## FAQ Title NFPA 805 Monitoring

Plant: Harris Nuclear Plant

Date: October 10, 2016

The purpose of this FAQ is to clarify the following for the NFPA 805 Monitoring Program:

### Figure E-1 – NFPA 805 Monitoring Process

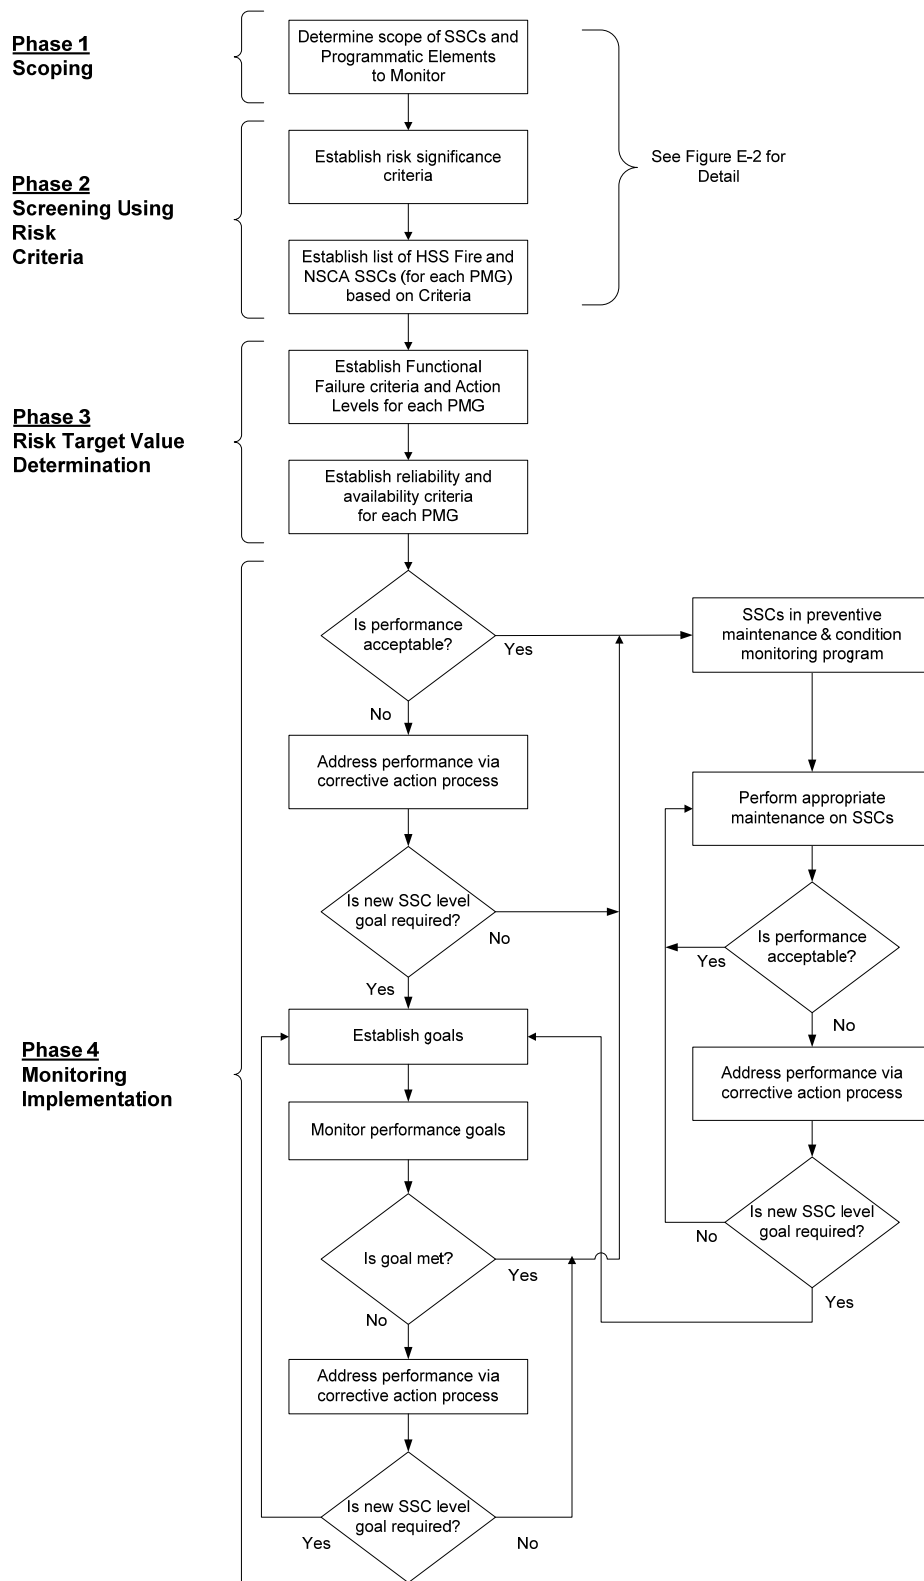
**REPLACE ALL OF APPENDIX E WITH THE FOLLOWING:**

A suggested methodology is outlined below. Figure E-1 provides an overview of the Monitoring Process, while Figure E-2 provides detail on a process for Phases 1 and 2.
